ADDENDUM NUMBER I

DATE: February 9, 2026

PROJECT: Newark Valley Central School District 2023
Capital Project – Phase III
High School Air Conditioning

SHEET NO.
M304-AD1

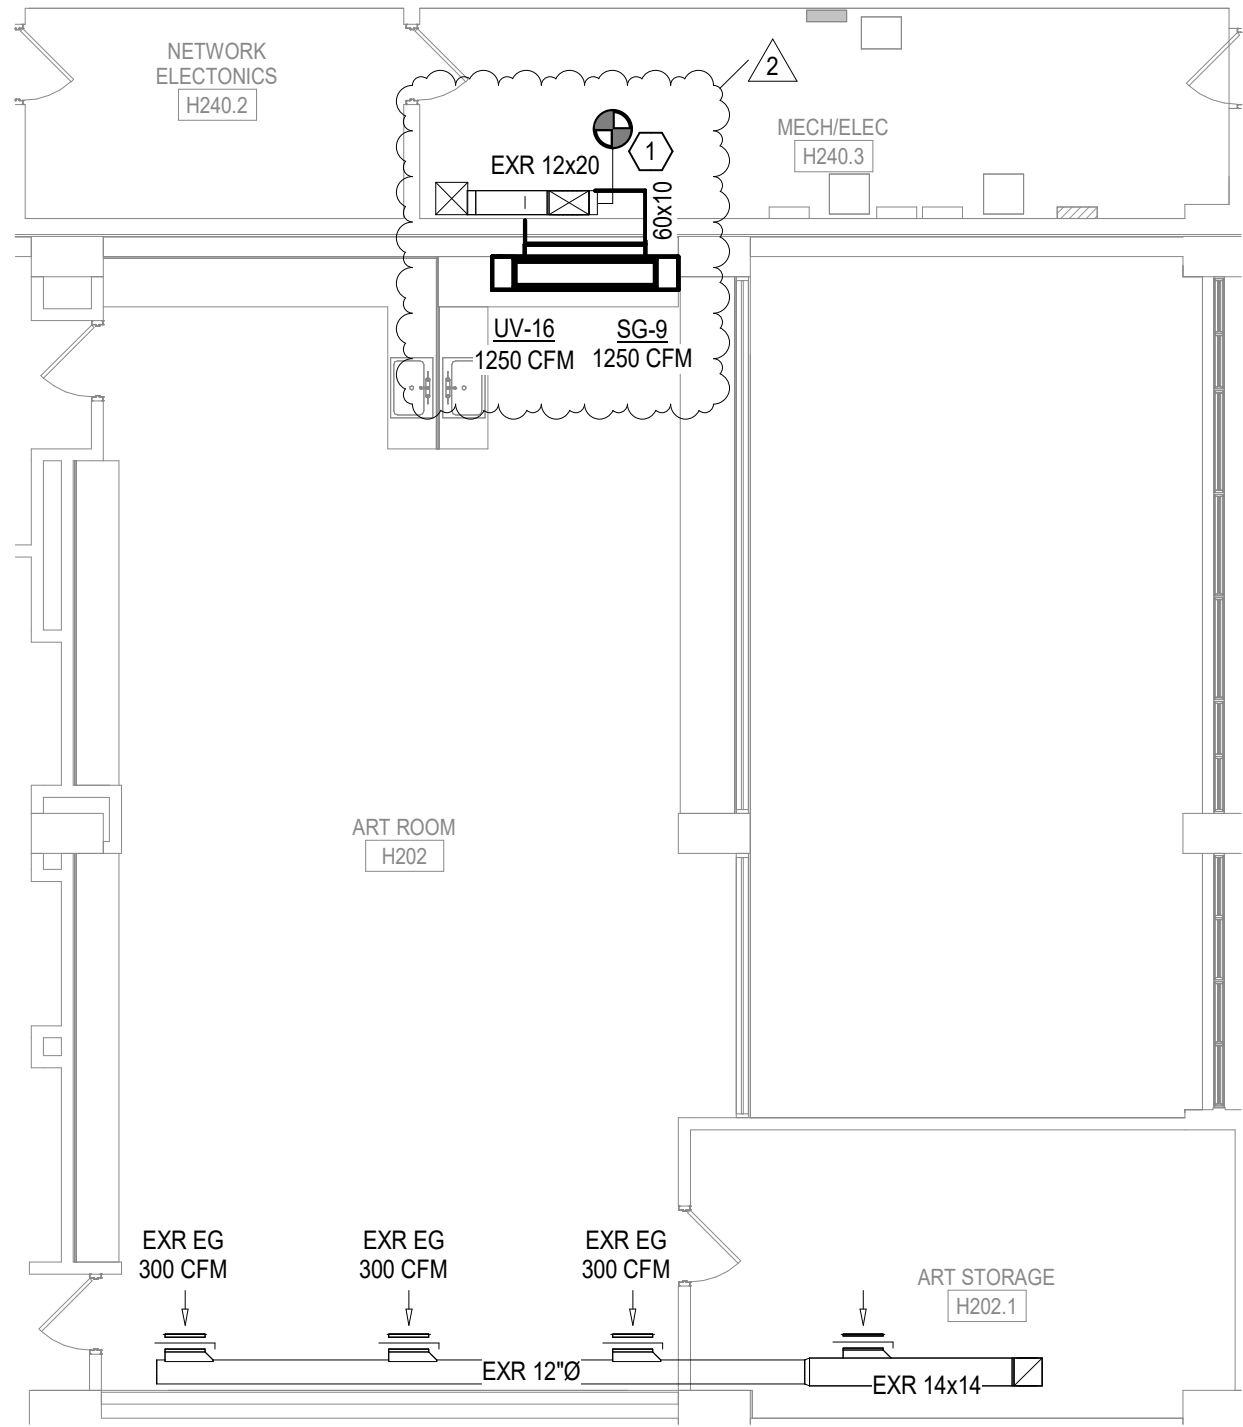
17. M304 - SECOND FLOOR DUCT PLAN - AREA 1
 - a. REVISE Chorus and Band rooms as shown on the attached drawing M304-ADI.
18. M305 - SECOND FLOOR DUCT PLAN - AREA 2

1 SECOND FLOOR DUCT PLAN - AREA 3 UPPER
M306-AD1 1/8" = 1'-0"

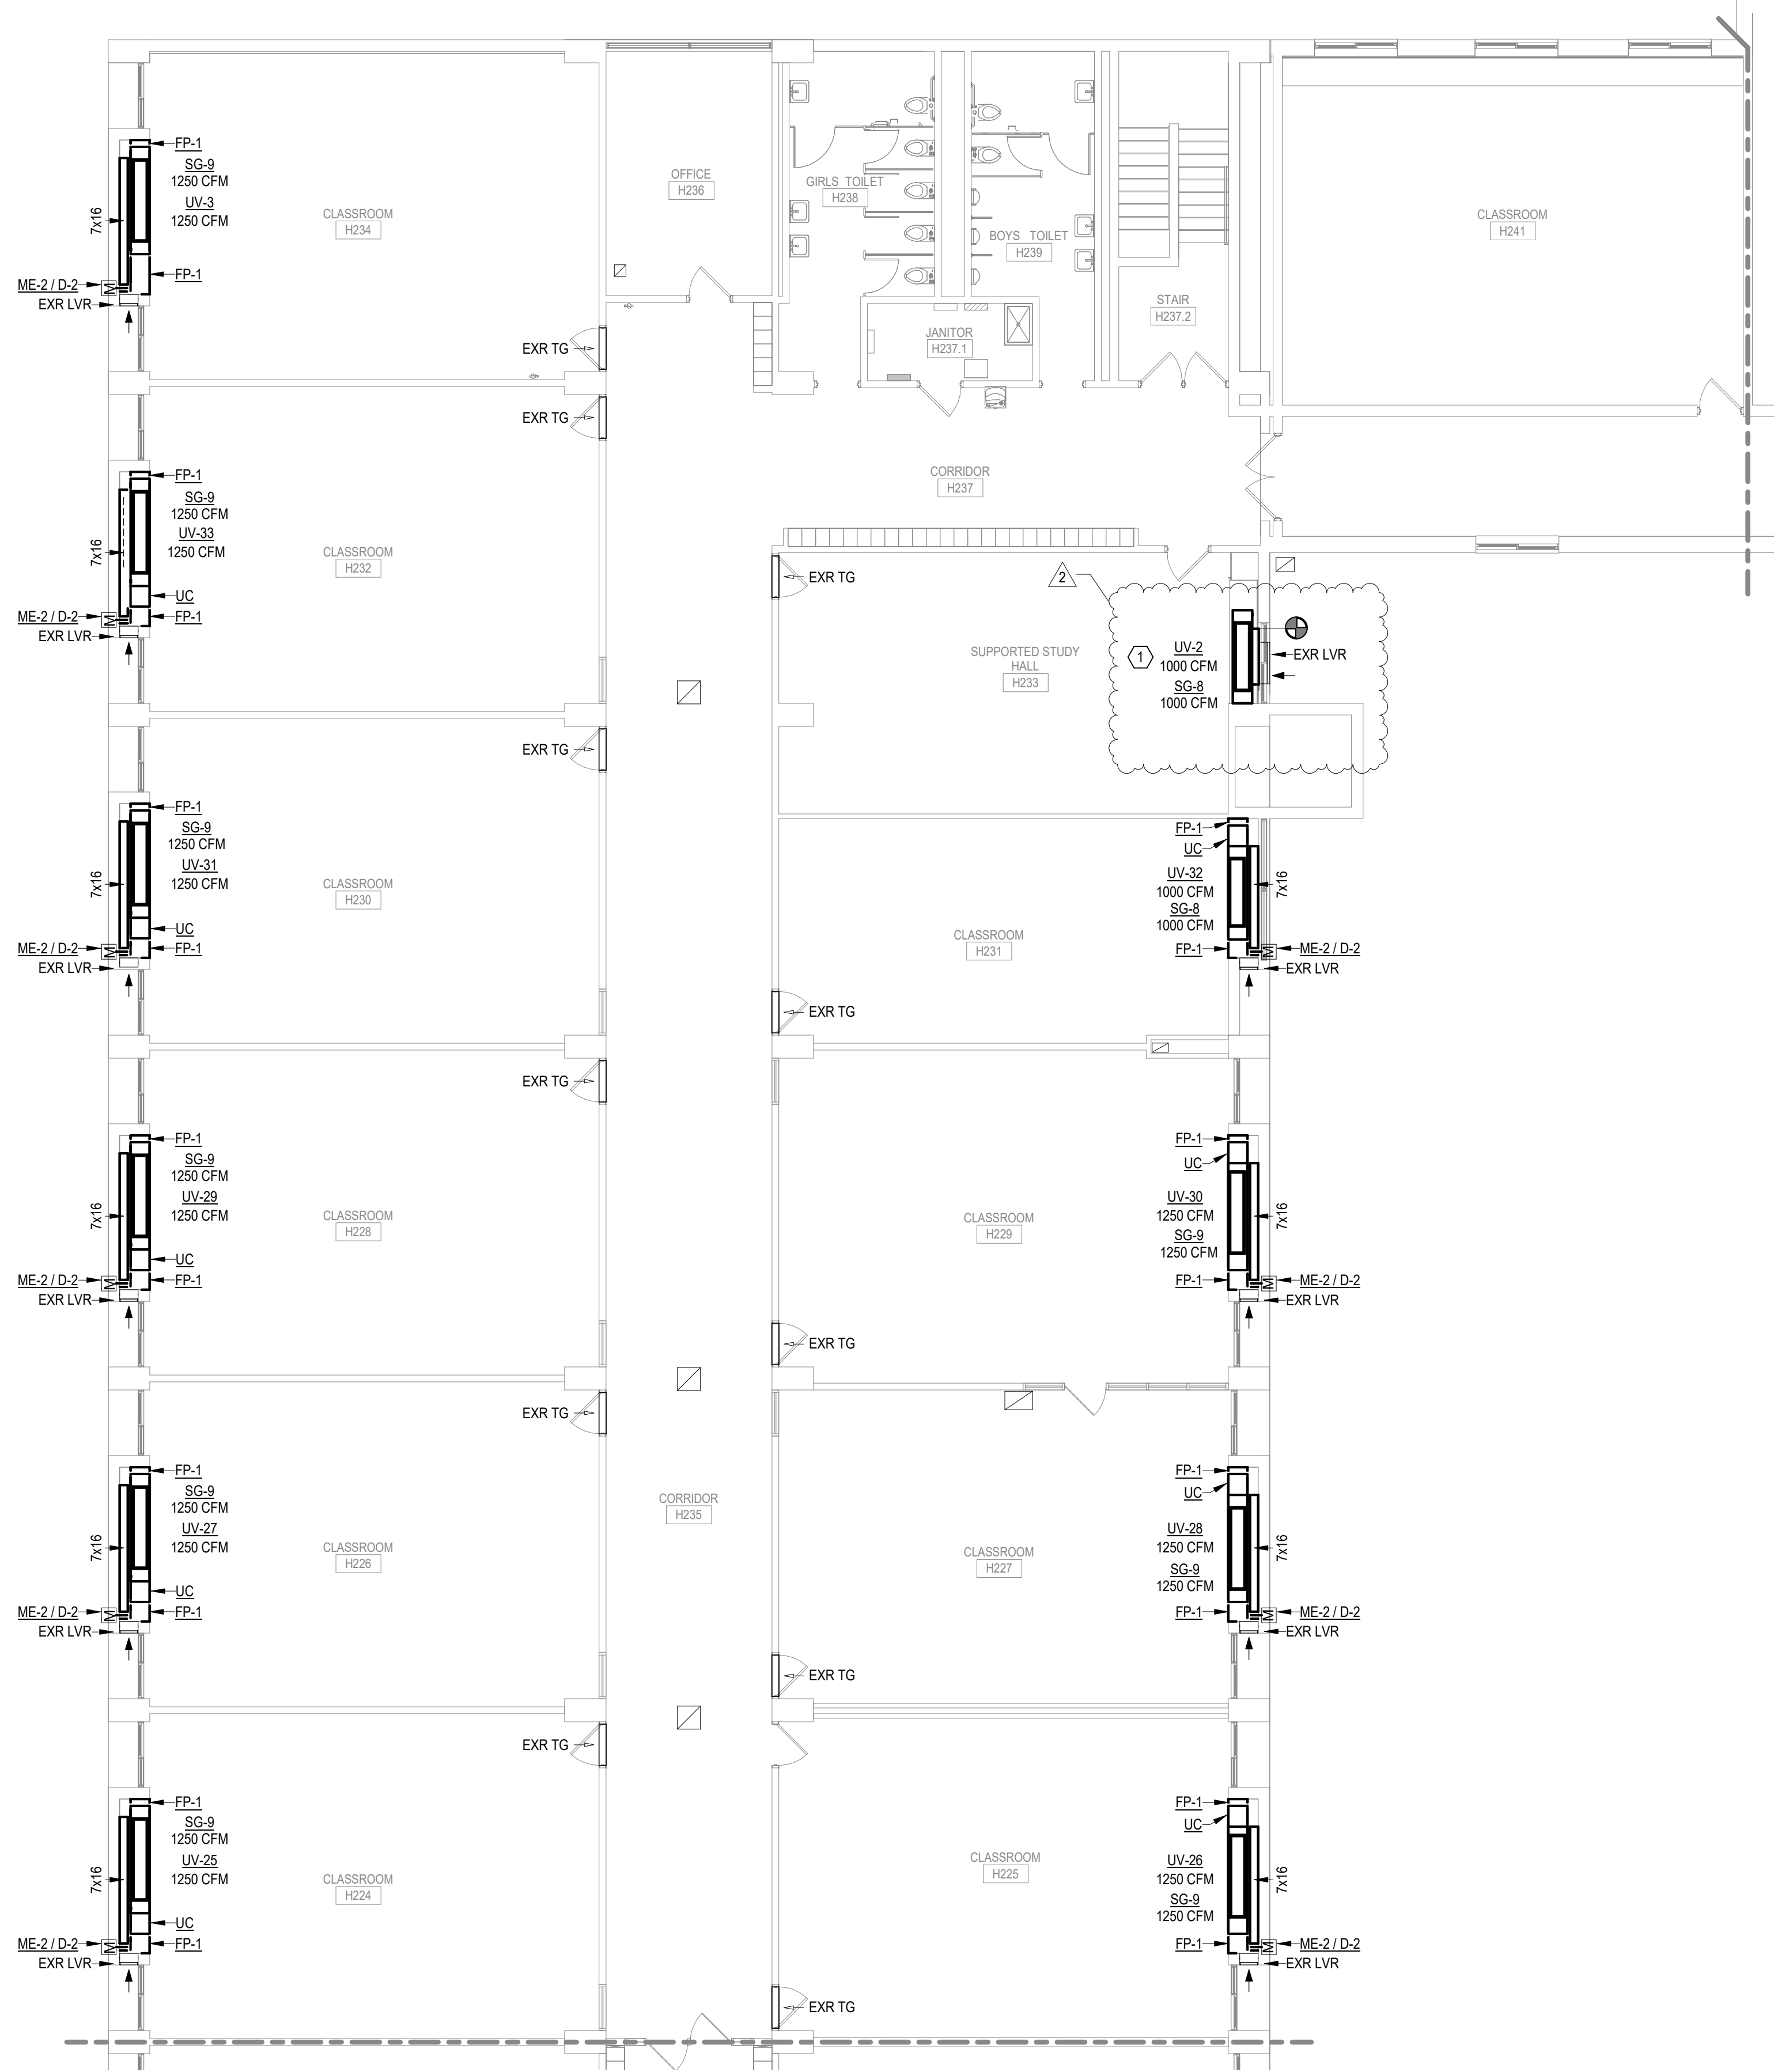
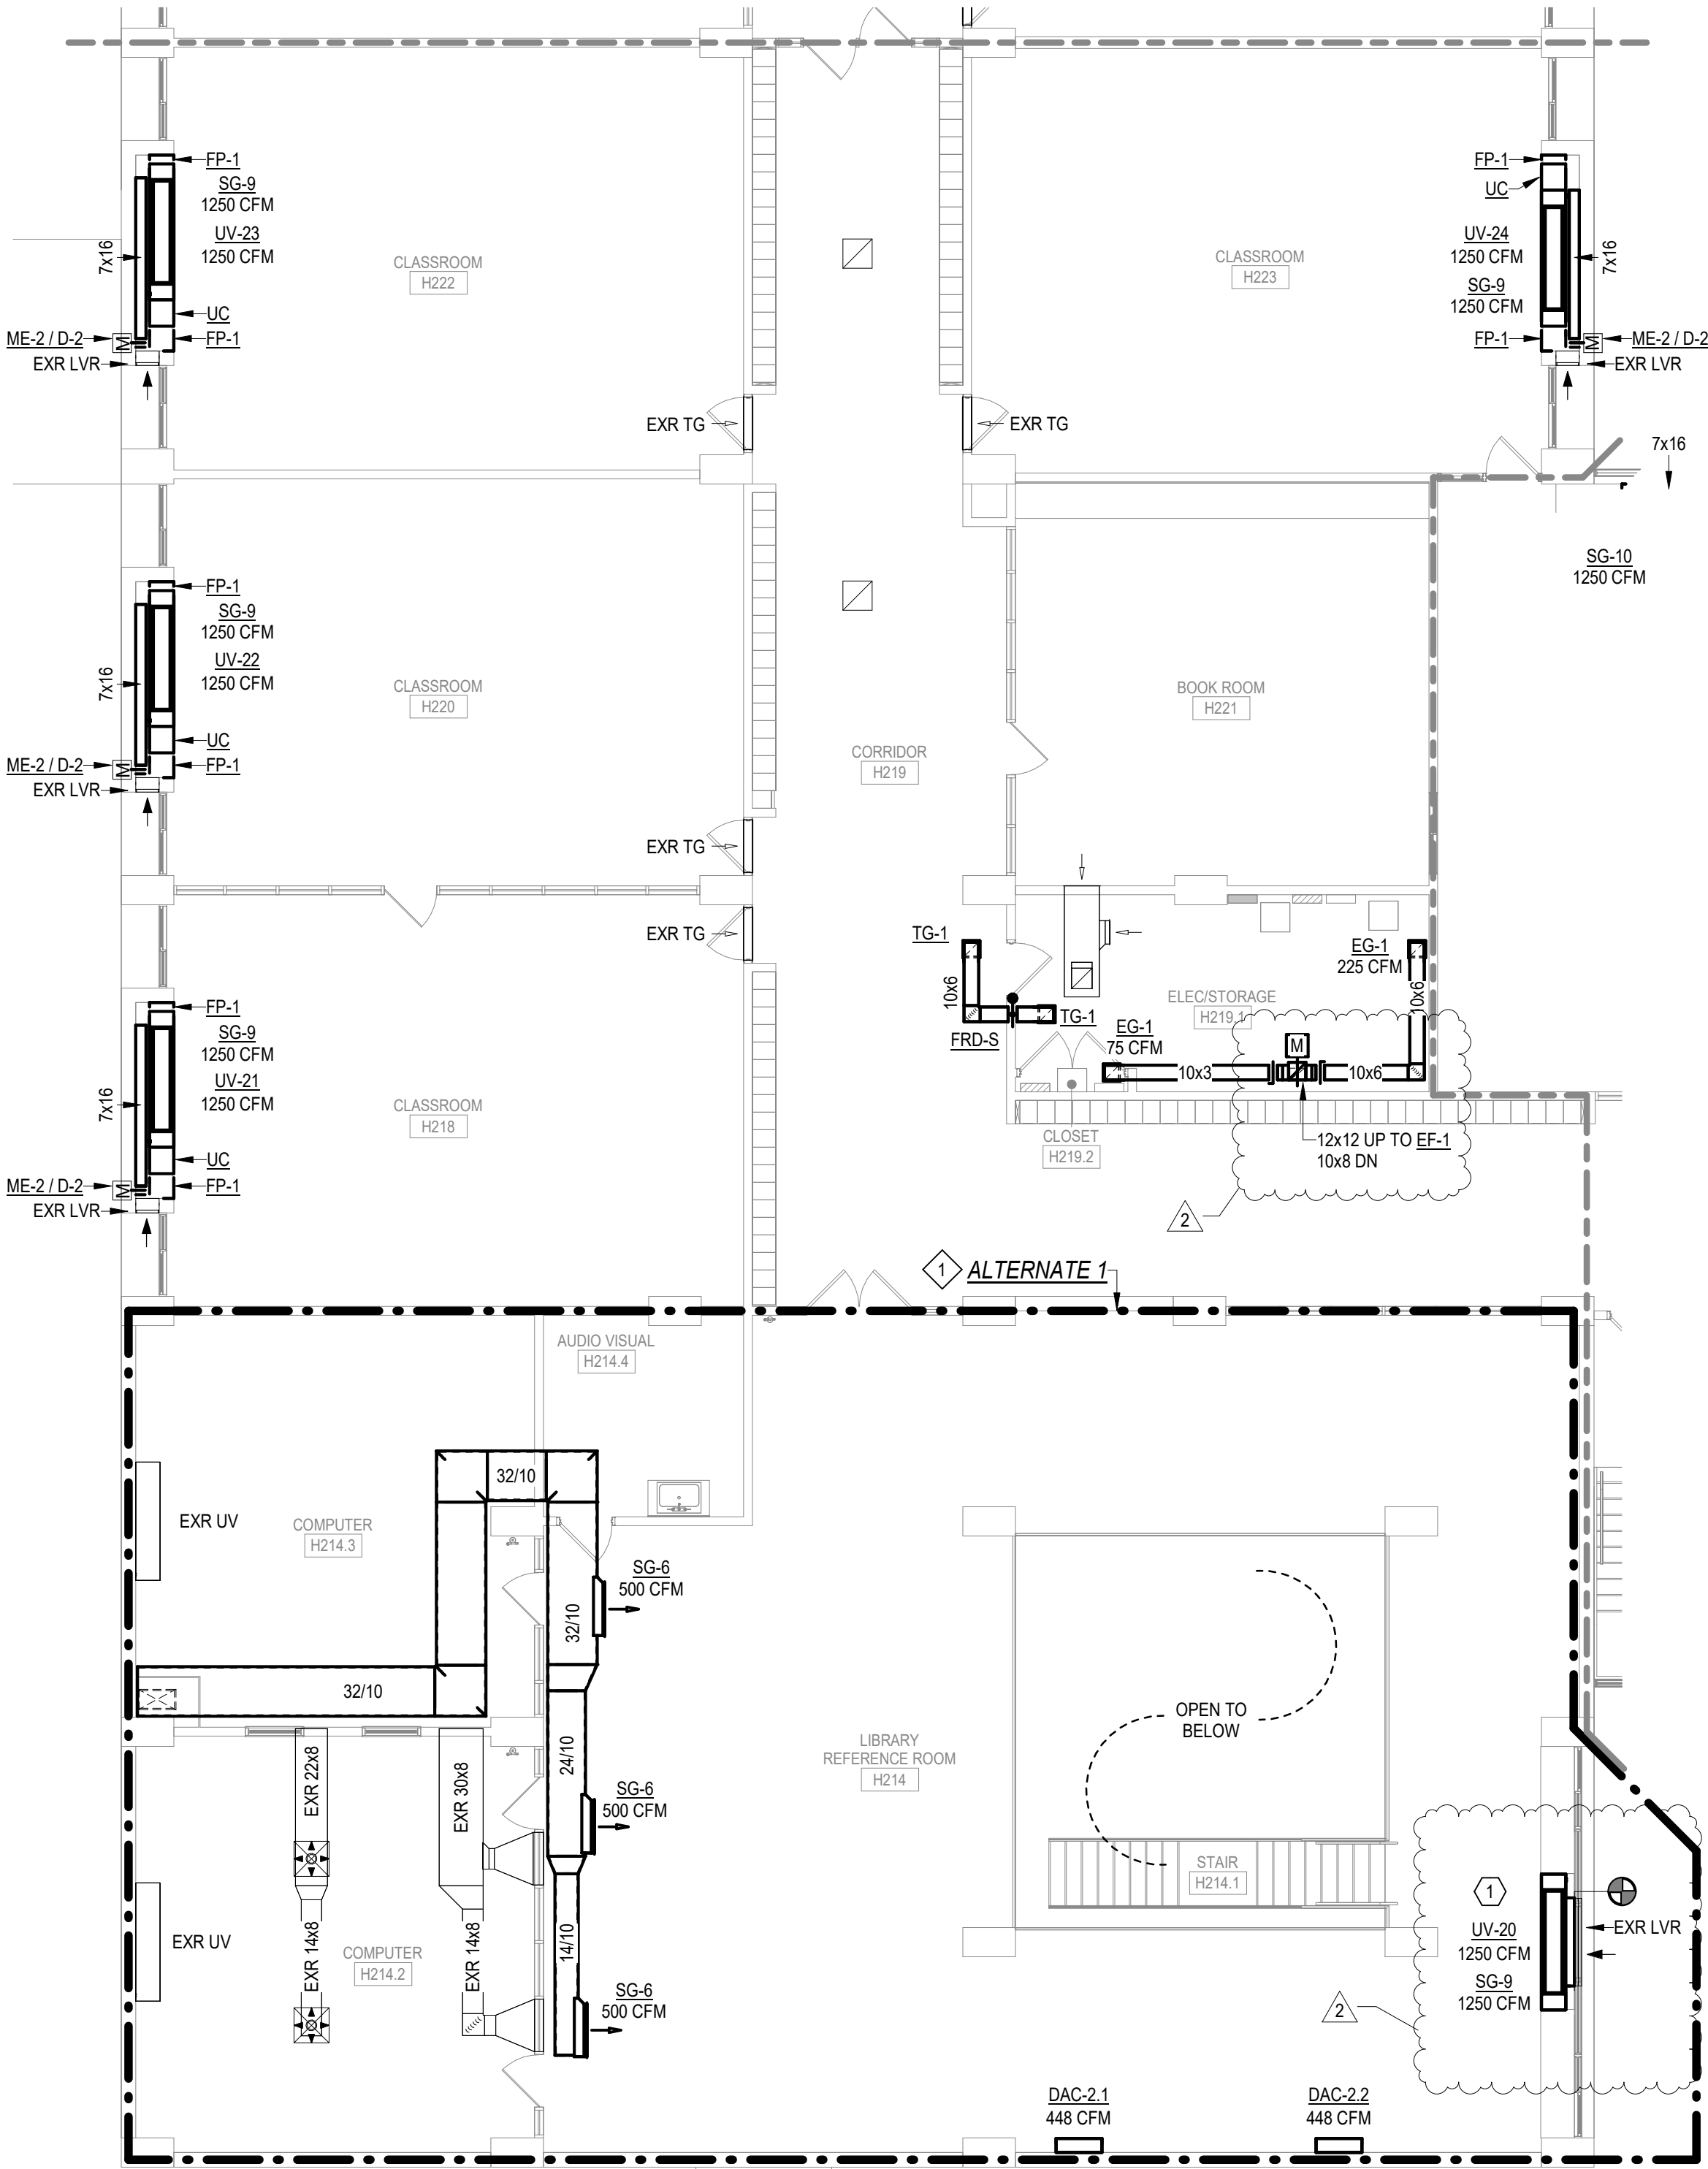
- a. REVISE as shown on the attached drawing M306-ADI.
20. M307 - ROOF MECHANICAL PLAN - AREA 1
 - a. REVISE as shown on the attached drawing M307-ADI.
21. M309-ADI - ROOF MECHANICAL PLAN - AREA 3
